RE: PART 3A DEVELOPMENT

Sir Moses Montefiore Jewish Home - Randwick – MP10-0044 + MP09-0188

100-120 KING ST + 30-36 DANGAR ST RANDWICK

OBJECTION ON BEHALF OF NORTH RANDWICK RESIDENTS

Eastern façade of Centennial Apartments

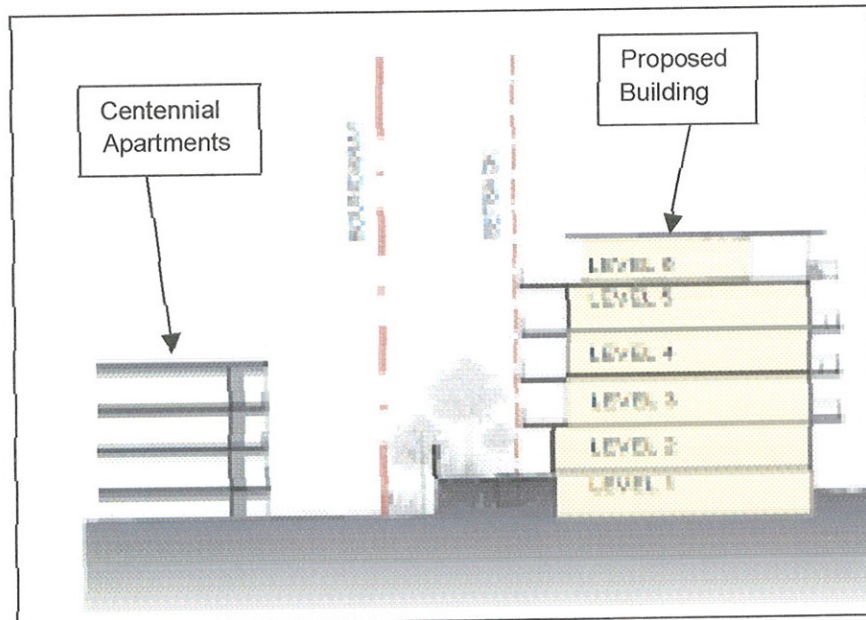
The proposed building F will completely obscure this aspect and will be 2-metres above the height of the building in the photo which is 70-metres away while the proposed building will be within 20-metres.

This expansive and green vegetated outlook will be replaced by a building 3-storeys above the uppermost storey of the Centennial Apartments.

Section plan demonstrating the existing building height of Centennial Apartments and the proposed building height.

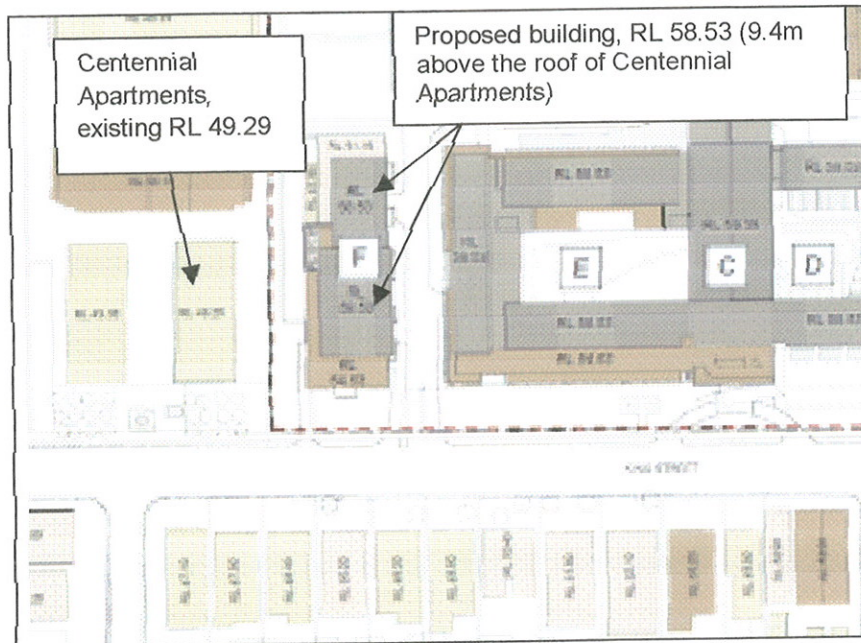
Such impact is also confirmed by the section showing the height of Building F being 3-storeys above Centennial Apartments while the landscape plan shows that there is no opportunity for effective screen planting due to the proximity of the child play area to the western boundary with Centennial Apartments.

The proposed height associated with new Building F under the Concept Plan is in breach of the height limit by up to 10.7m which is equivalent to 3 storeys. Such excess is associated with a Building F which has a length of over 60-metres. This has severe visual impacts to Centennial Apartments (the immediately adjoining western neighbour – as shown in the photos above). Furthermore the eastern side setback which includes private open space areas would also be overshadowed.

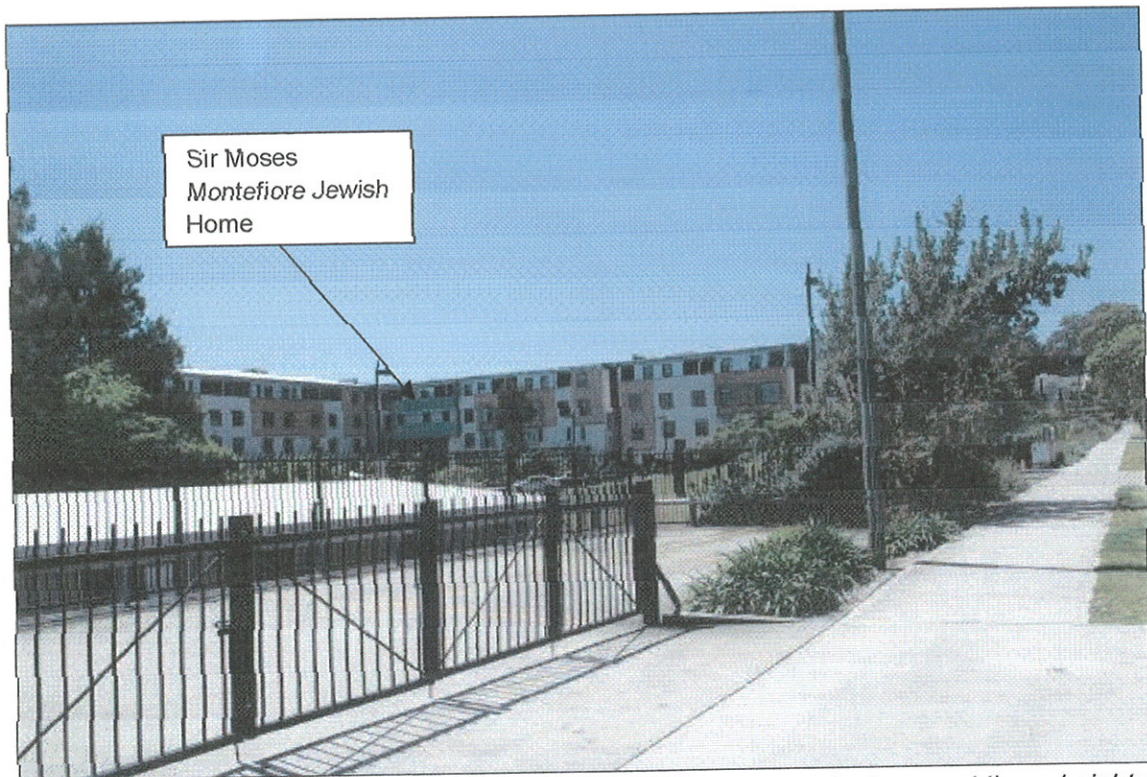
King Street consists of 1 and 2 storey dwellings. The scale of a 4 storey structure will be inappropriate opposite the 1 and 2 storey dwellings.

Existing 4 storey building heights within the site. The proposal seeks to repeat these heights along the street frontages.

Photo demonstrating the existing RL of buildings on the corner of Church Street and King Street and the proposed height of the Sir Moses Montefiore Jewish Home.

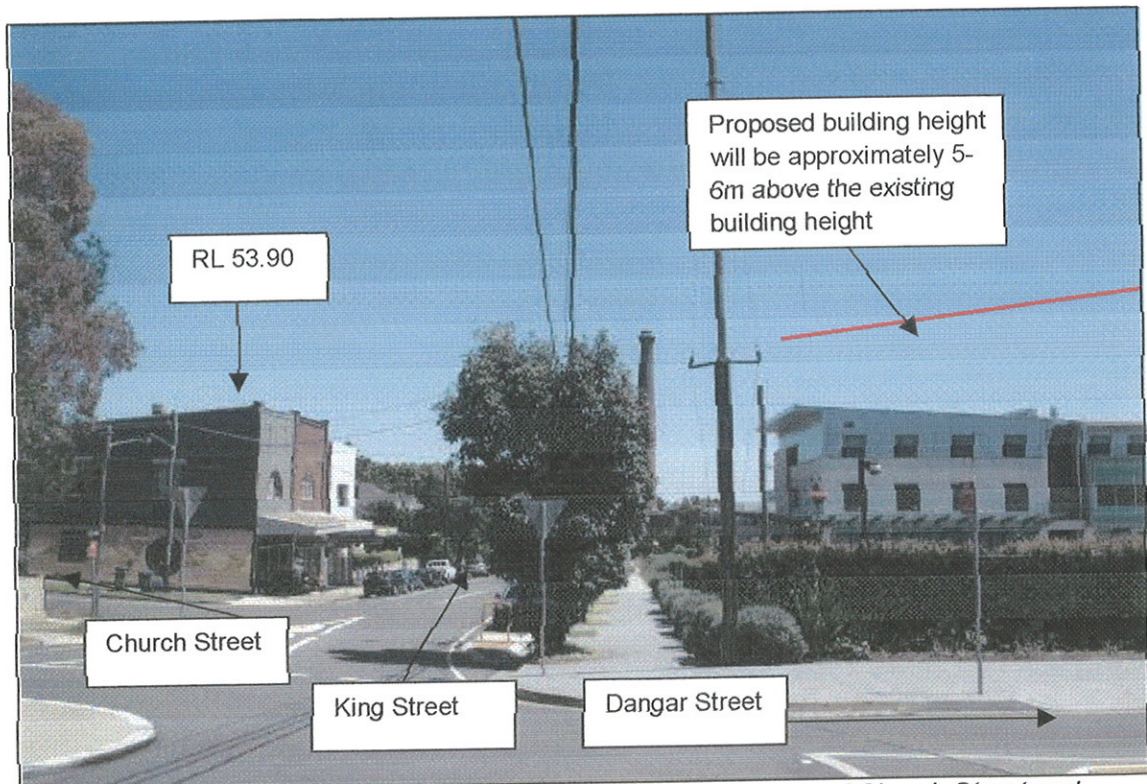
The other height increases along King and Dangar Streets are also out of character with the surrounding area and are proposed at the perimeter of the site where they will be most evident.

Photo of existing light spillage taken from Centennial Apartments at 8.30-9pm

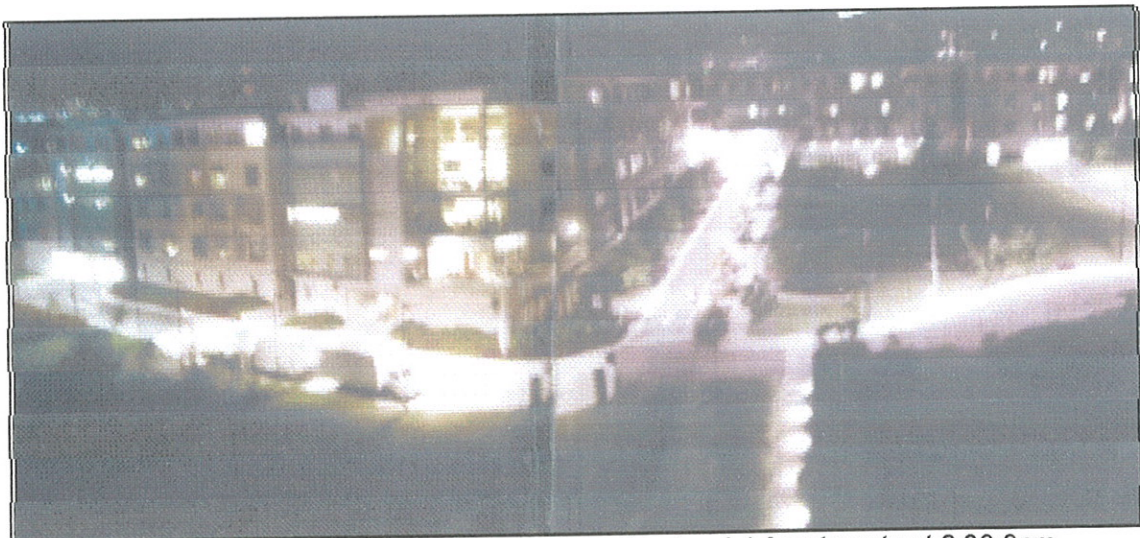
Surrounding residents have already experienced significant light spill impacts. It is considered that the proposed further encroachment of buildings towards residential neighbours and additional building heights will only add to this impact.

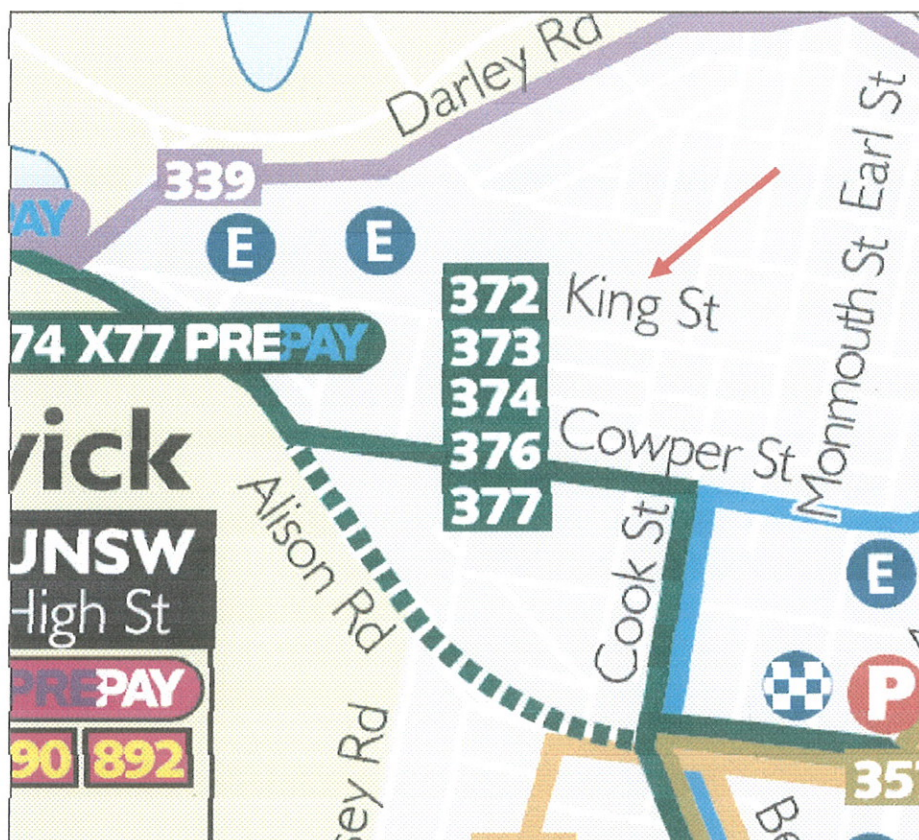
Both the Statement of Heritage Impact and the Environmental Assessment Report state that the Montefiore site lies to the south of the conservation area yet make no reference to the fact that the conservation area also lies immediately to the east of the subject site. This is considered to be a major issue as it appears that the bulk and scale of the new buildings along Dangar Street and their impact upon the setting of the conservation area have not been taken into account. When looking north and south along Dangar Street to and from the heritage conservation area, the proposed buildings and the dwellings in the conservation

area will be in the same visual catchment, as shown below. This highlights the deficiency in the heritage and planning assessment.
